**ORDINANCE 15-15**

**TO AMEND THE APPROVED PLANNED UNIT DEVELOPMENT (PUD) DISTRICT  
ORDINANCE AND PRELIMINARY PLAN  
- Re: 2602 E. Creeks Edge Drive  
(Evergreen Partners II, LLC, Petitioner)**

**To: Members of the Common Council**  
**From: Eric Greulich, Zoning Planner**  
**Subject: Case #PUD-16-15**  
**Date: August 14, 2015**

**Subject:** PUD-16-15, Evergreen Assisted Living facility, second hearing  
2602 E. Creeks Edge Drive

Site Plan

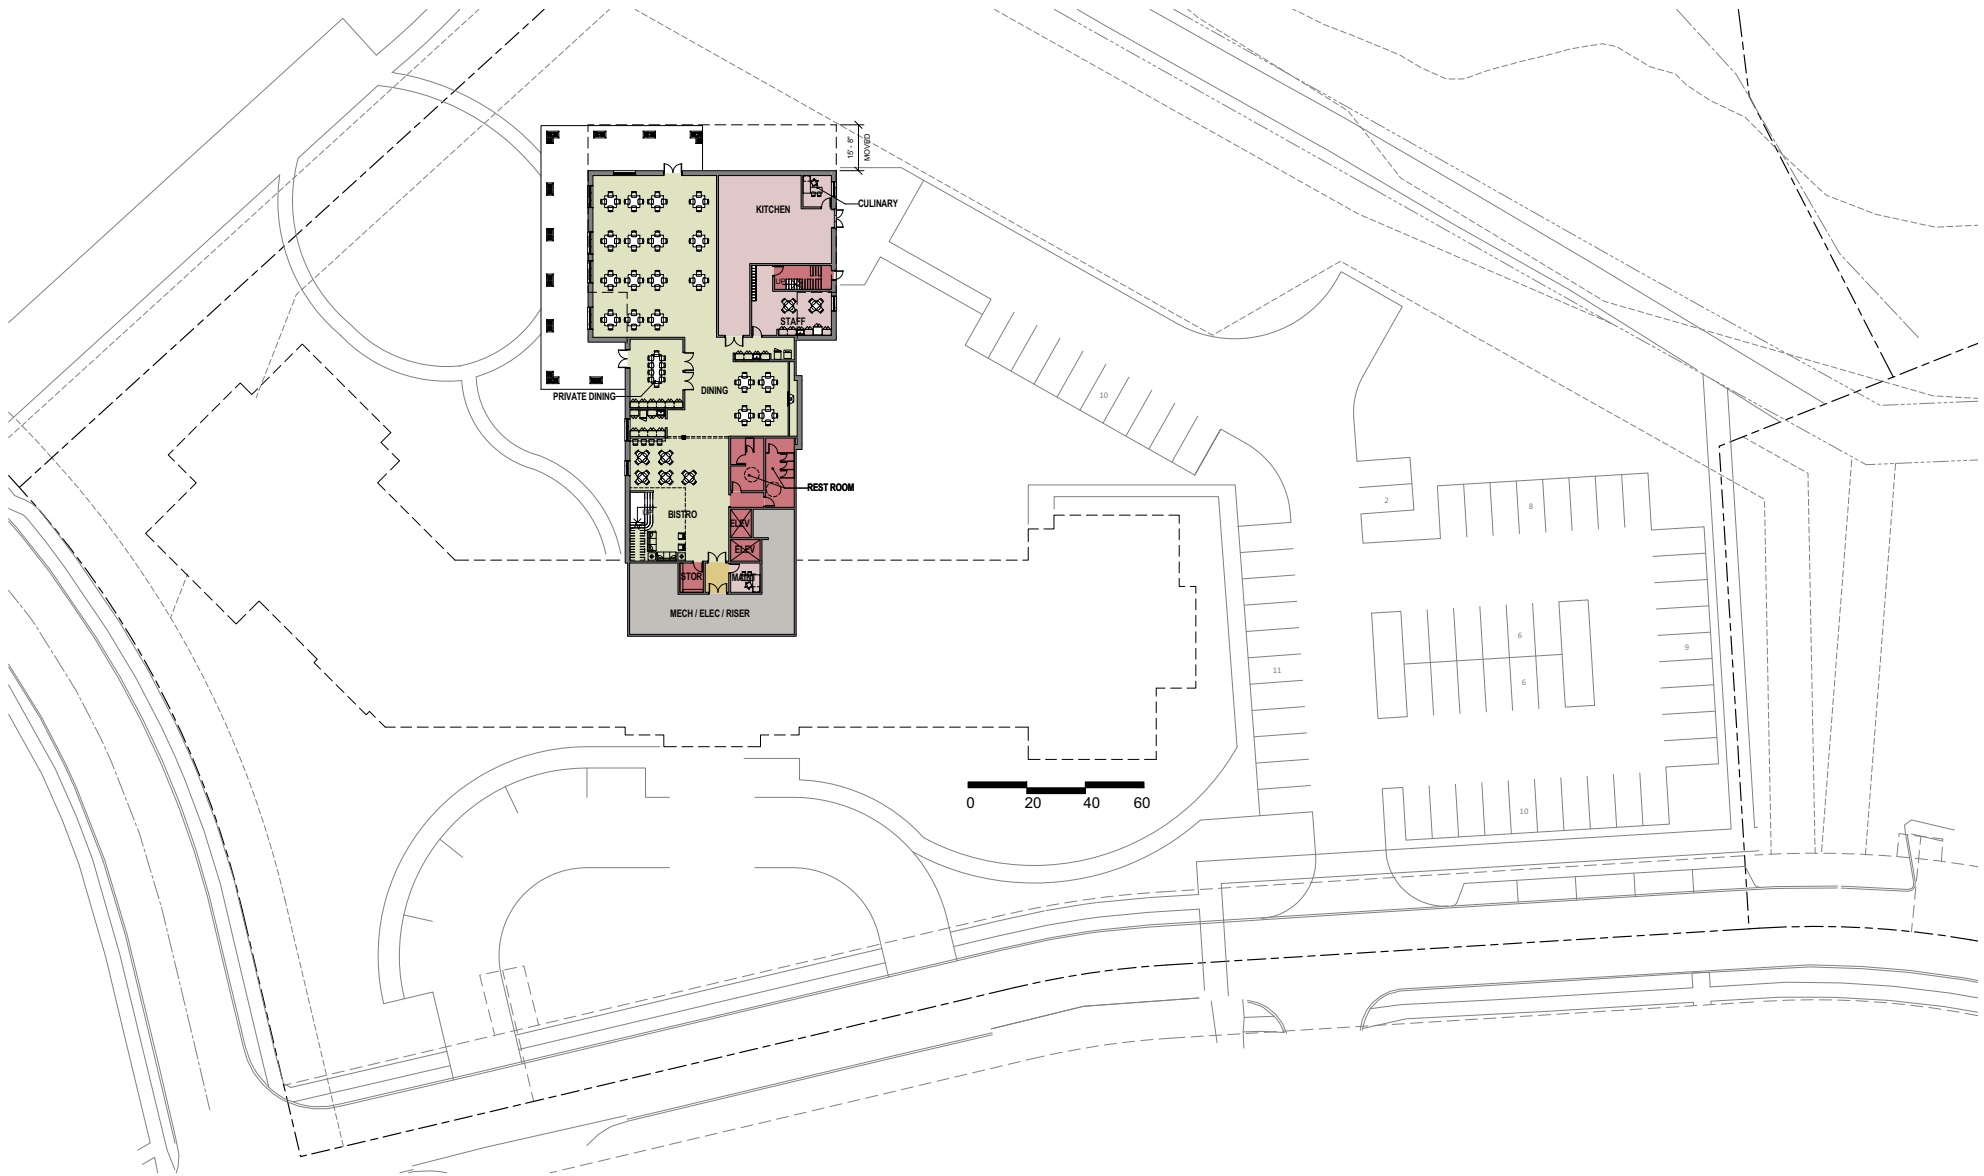
**Access:** There is a circle drive proposed along the private internal drive to provide access to the front and to facilitate drop-offs. There is a covered awning proposed that extends over this driveway and entrance. There is another drivecut proposed along the internal driveway for the parking area located in the rear of the property. A sidewalk and street trees were required along the west side of the internal driveway with the previous

petitions for the multi-tenant building and the daycare facility, and would be required along the east side of the internal drive as well with this petition. A secondary emergency access drive has been shown along the east side of Lot #5 to provide an additional access point for emergency services.

1. The petitioner will continue to work with staff to review the possibility of rotating the building orientation to face Creek's Edge Drive prior to PUD final plan approval.

- Though the Plan Commission expressed support for the building height and general look, comments were made with regard to reducing the overall mass of the building where possible. Based on feedback from our market analyst and the Plan Commission we will be reducing the numbers of apartments at the project from 125 units to 115 units. This is expected reduce the overall building size to approximately 107,133 from the prior layout of 112,924. The north wing has been reduced by 13'-2" and the East wing (rear of the building) by 15'-8".

- We have been able to increase the total number of parking spaces to 67 from 62. As part of the installation of the new sidewalk/bike path along E. Canada Drive, we will likely need to remove the 9 existing horizontal parking spaces utilized by Lot 2 via the Parking Easement. We are currently planning to replace these spaces with 5 new parallel parking spots. We have shared this proposed change with the owner's of Lot 2. If necessary, we will work with them to amend the parking easement to allow for some form of a shared parking arrangement to exist between the two sites.

- We are proposing adding a bike path that will connect to the property at E. Canada Drive and will connect to the Jackson Creek Trail path via access we will provide along the boundaries of Lot 4 and Lot 3. We have redirected the bike path along the property line to minimize conflicts between public bicyclists and private parking area pedestrians accessing our facility. By turning the path to the south and avoiding long straight-a-ways, bicyclists will necessarily have to slow down through this area. These precautions will reduce the opportunity for accidents to occur.

- We are proposing adding a combination public walking path and emergency access road within Lot 5. This path/road will provide a sidewalk connection to E. Creeks Edge Drive and the Jackson Creek Trail. The multi-purpose path will be clearly distinguished from the sidewalk along E. Canada Drive, per the PUD requirements. Access will be limited to pedestrians and emergency vehicles. Access by bicycles and non-emergency motorized vehicles will be prohibited. Beyond the point where emergency vehicle access is needed we are considering narrowing the multi-purpose path and/or utilizing bollards to limit access to Jackson Creek Trail only to pedestrian traffic.

- We propose a native plant zone for the area East of the parking lot and service drive, extended to the north property line as indicated on the revised site plan. Any plants installed within this area will be Midwest native species.
